Site Plan Review Committee (SPRC)
Staff Report for
1400 Richmond Highway (Americana Hotel)
SPLN22-00004

1400 Richmond Highway (SPLN22-00004)
Americana Hotel
(RPC #35-001-002, -003)

SITE PLAN REVIEW COMMITTEE
MEETING AGENDA

Figure 14. Proposed Tower Separation

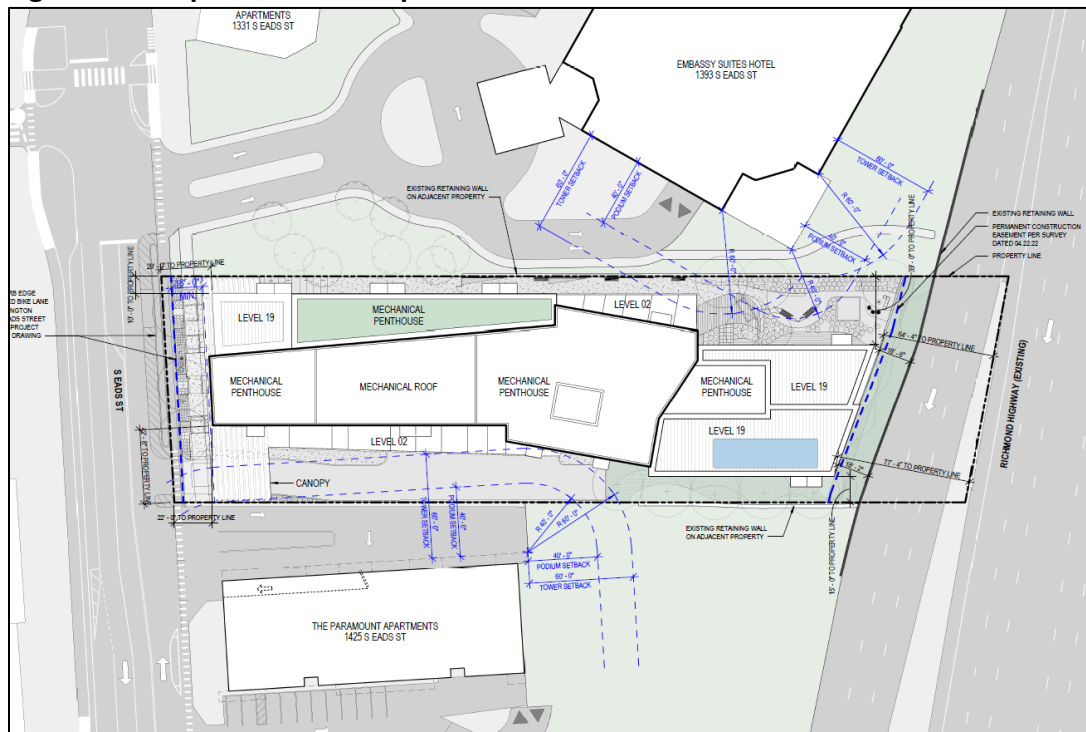
- **Building Tower Separation and Coverage:** The ACZO requires a minimum horizontal separation of 60 ft between building towers above the 5th floor and building tower

coverage not to exceed 65% for the subject site. The proposal meets the tower separation between buildings and has a tower coverage of approximately 57.1%.

Figure 16: Proposed Ground Floor Plan (Existing Richmond Highway Alignment)

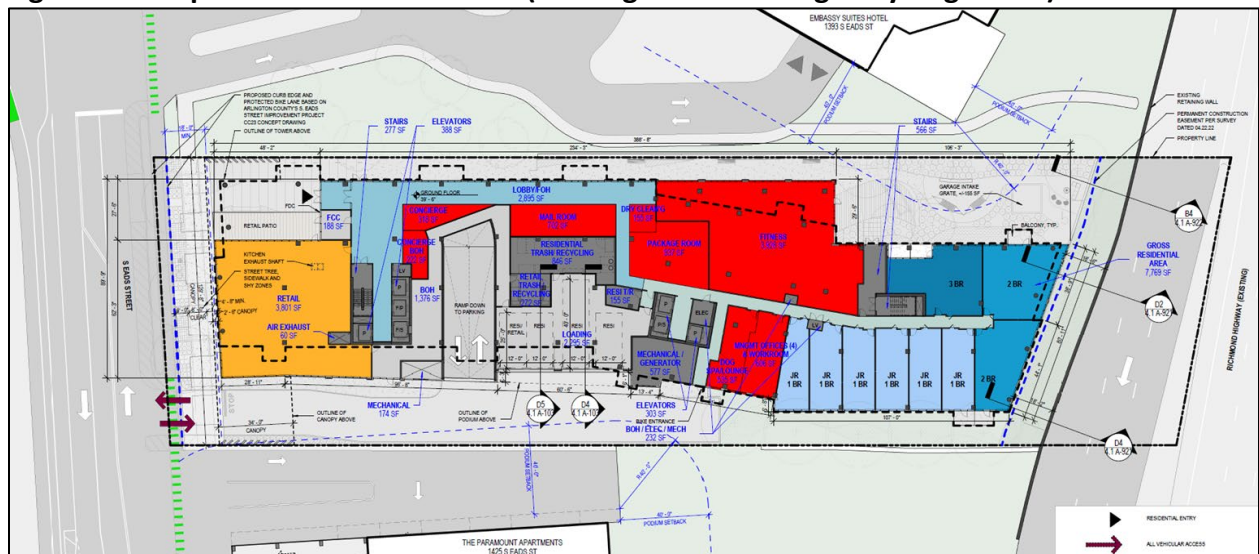
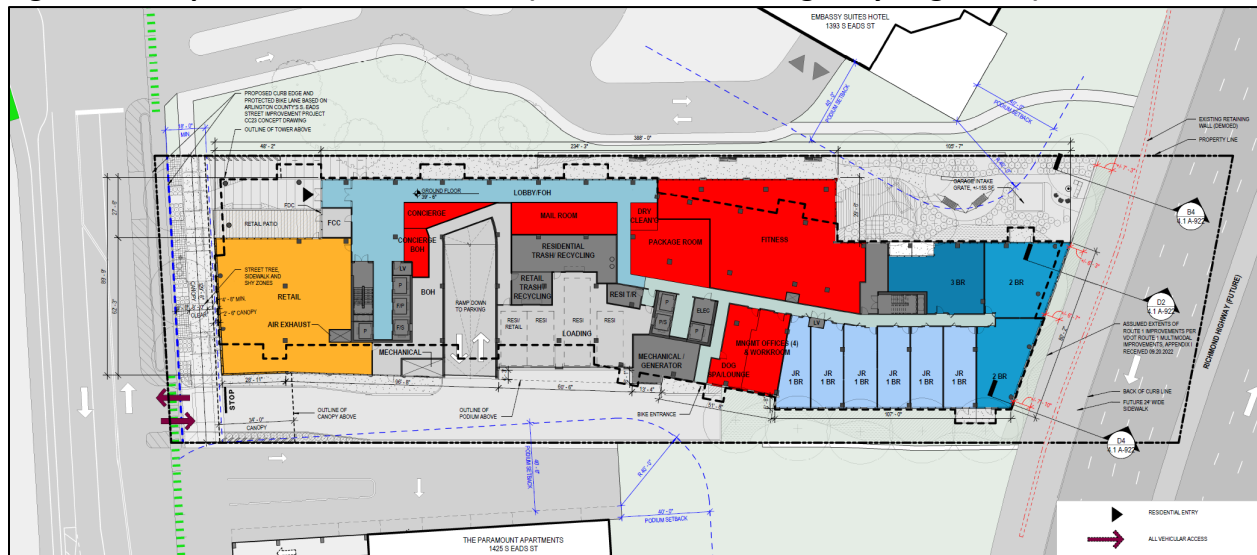
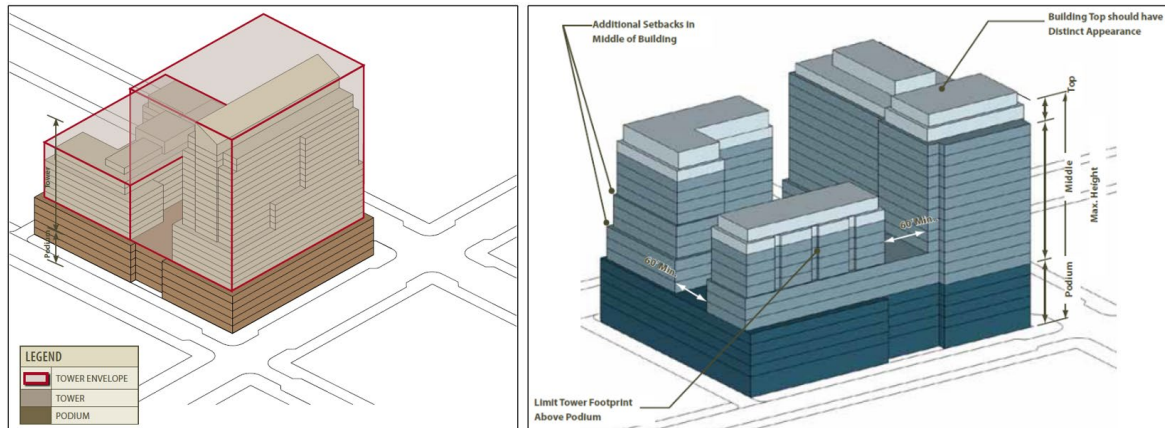
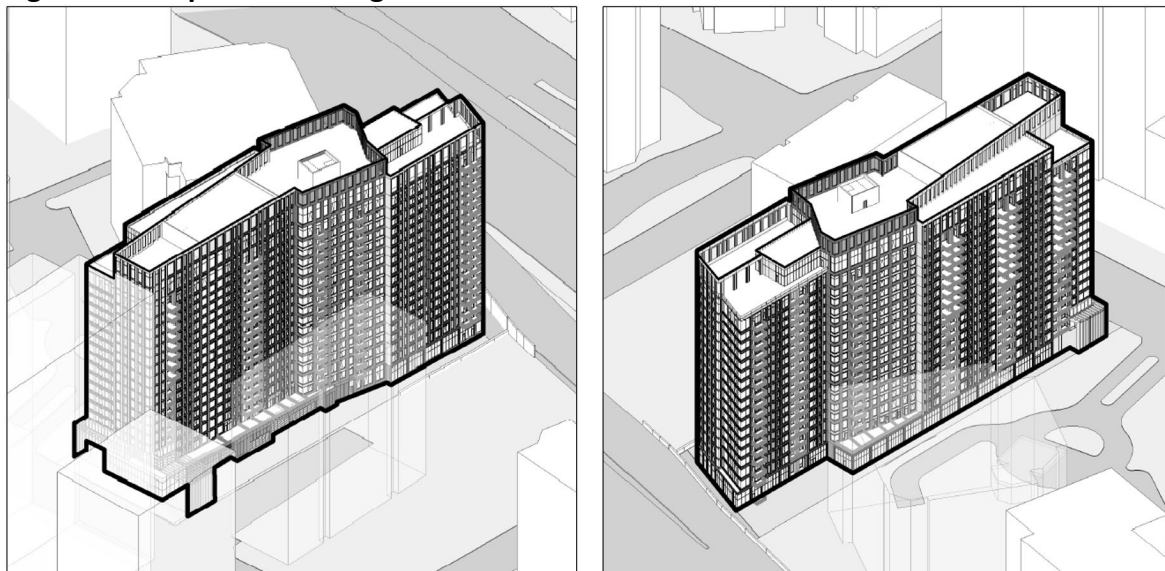
Site Design: The applicant proposes a 19-story residential building with 2 levels of underground parking. At its closest point, the building is set back 10.5 ft from the northern property line and 10 ft from the southern property line. The ground floor uses include retail on the western end of the building, the residential lobby, amenities and parking and loading in the mid-section, and residential units on the eastern end. While the retail entrances are located at the back of the sidewalk, the residential entrance is set back approximately 48.2 ft on South Eads Street. A driveway and a single curb cut are located at the southwest corner of the site, which leads to the parking garage entrance and loading docks. The applicant also proposes an approximately 4,000 sf ground floor private terrace in the northeast corner of the site, which results in a portion of the Richmond Highway building frontage set back approximately 106.3 ft from the building face. The remainder of the Richmond Highway building frontage is approximately 18 ft from the existing Richmond Highway alignment and 6 to 8 ft from the future Richmond Highway alignment.

Figure 20: Proposed Elevations

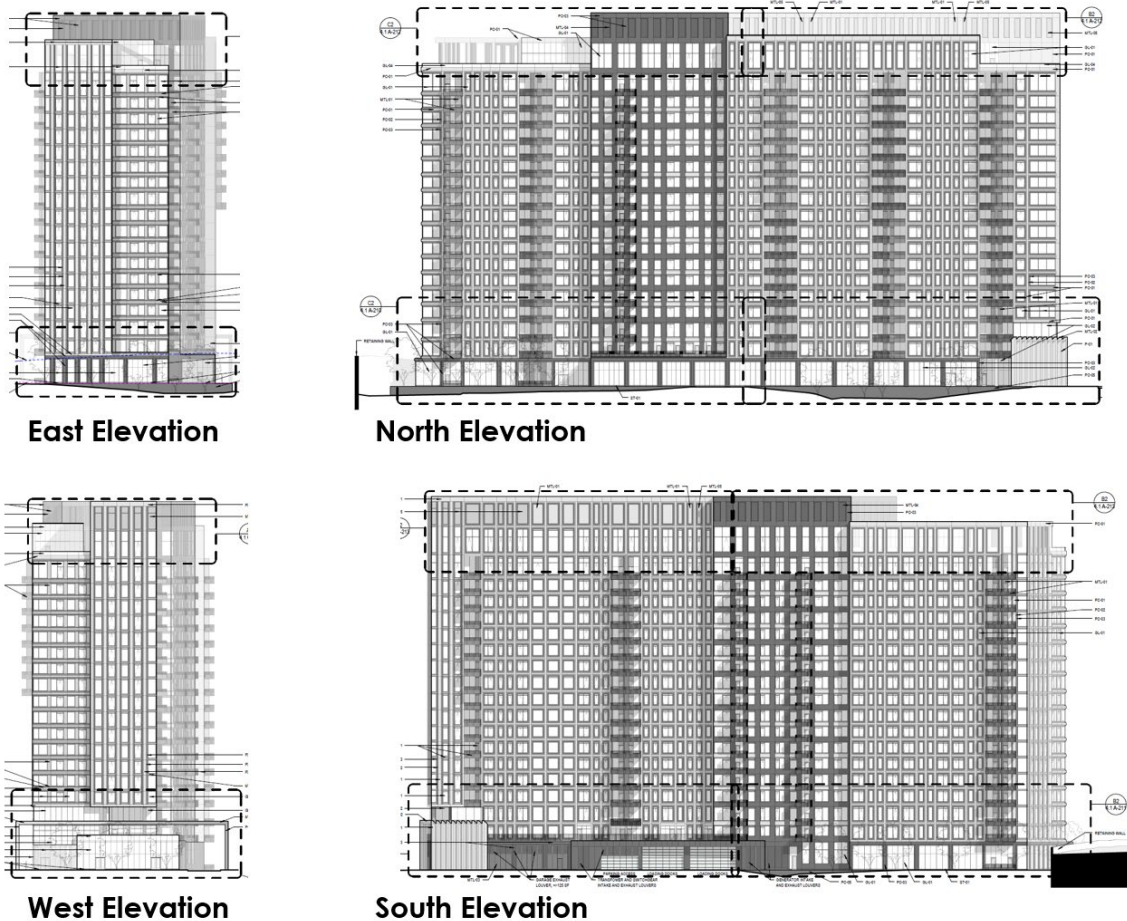
Architecturally, the building is long and narrow (approximately 388.7 ft long and 89.8 ft wide) and follows the dimensions of the property. To avoid a flat and rectilinear façade, the building is angled slightly in 2 places. The podium consists of a single floor, 18 ft in height, and is comprised of dark gray metal and pre-cast concrete panels. The building tower is comprised of light and dark gray metal and pre-cast concrete panels, with each building face consisting of uniform fenestration. Each floor is approximately 9.7 ft in height and the north and south facades include balconies with metal railings. The building top consists of the 19th floor, 16.8 ft in height, as well as mechanical penthouse screening, 15.1 ft in height. The building top is

comprised of light and dark gray metal and pre-cast concrete panels. The South Eads Street building frontage incorporates a 30-foot, metal-cladded canopy structure that spans the street frontage.

Figure 22. Proposed Overall Landscape Plan

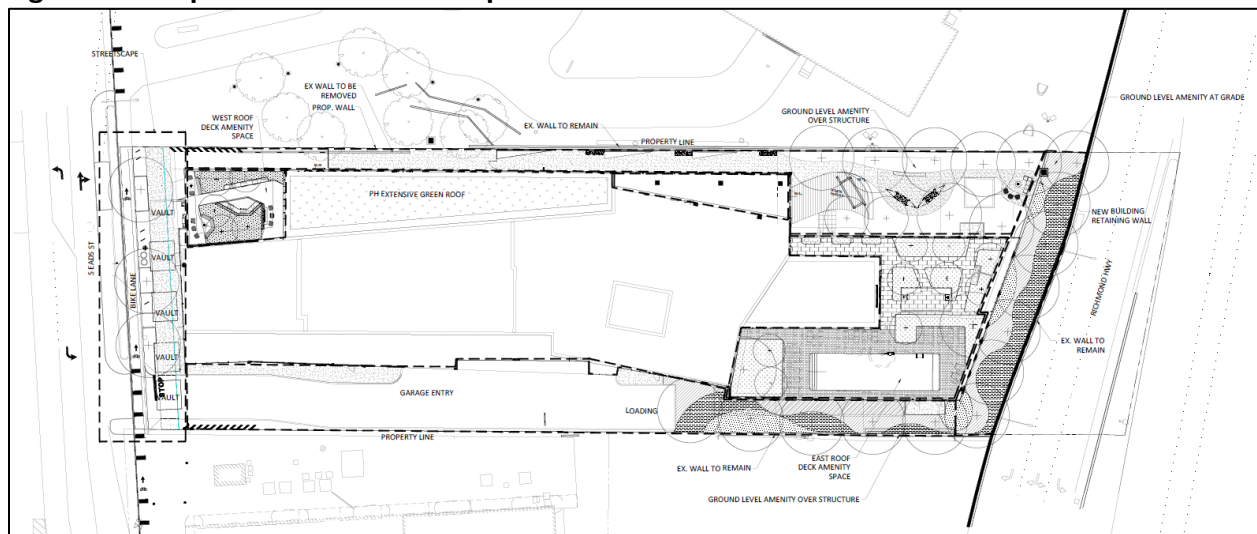
Open Space and Landscaping: The applicant proposes an approximately 4,000 sf ground floor private terrace in the northeast corner of the site with various tree plantings and shrubs. A 10-foot pathway with small planting areas runs along the northern edge of the site which connects the private terrace and the lobby entrance on South Eads Street. While not publicly or privately accessible, the area between the building and the eastern and southeastern edges of the site is proposed to include 12 new trees. The building also includes 2 outdoor amenity terraces on the 19th floor that include raised planting beds for trees and shrubs and an extensive green roof above a portion of the 19th floor. Overall, the applicant proposes a tree canopy coverage of 18.8%. This includes the 3 street trees on South Eads Street. Impacts to the open space and landscaping on the eastern building face as a result of the VDOT study and potential changes to Richmond Highway are being evaluated by staff.

Figure 23. Proposed South Eads Street Cross-section

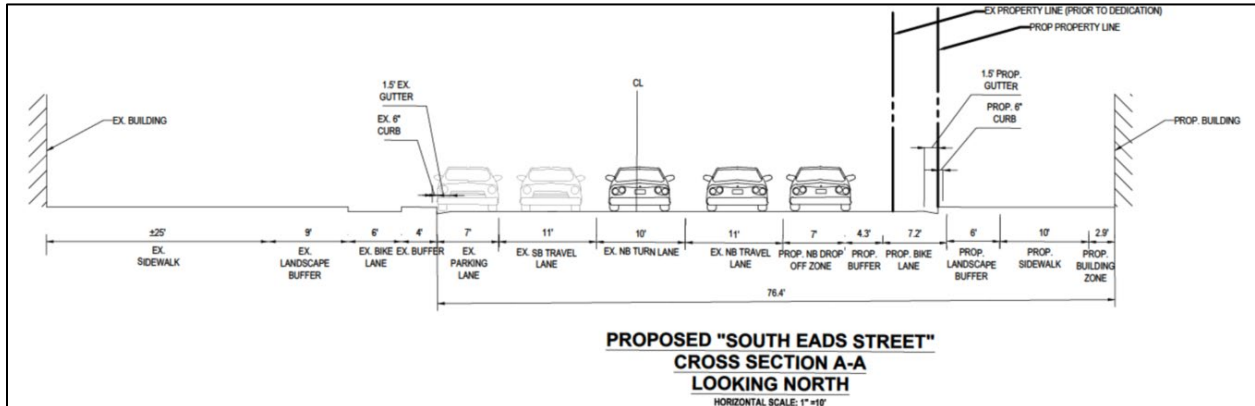
South Eads Street: The site is bounded by South Eads Street to the west, which is being designed in accordance with the County's [South Eads Street Complete Street](#) project to create a safer, more accessible and more comfortable environment for all users. The project will add physical protection to the existing bicycle lane, reconstruct and realign sidewalks, install street lighting and make necessary utility modifications and upgrades along the northbound side of South Eads Street between 12th Street South and 15th Street South. The southbound side of the street will receive improvements as part of Amazon's HQ2 at Metropolitan Park development. The curb-to-curb street width will be approximately 57 ft and consist of 2 travel lanes and 1 turn lane, as well as a parking lane on the west side and protected bike lanes separated by

raised medians in each direction. The Americana Hotel streetscape will consist of a 10-foot sidewalk, 6-foot landscaped buffer and an approximate 2.9-foot shy zone. The MTP identifies this section of South Eads Street as a Type-B Primarily Urban Mixed-Use arterial, which recommends a 6 to 12-foot sidewalk and a 6-foot furniture zone/tree pits. The Sector Plan recommends an 18 to 22-foot sidewalk, including a 6 to 7-foot furniture zone/tree pits.
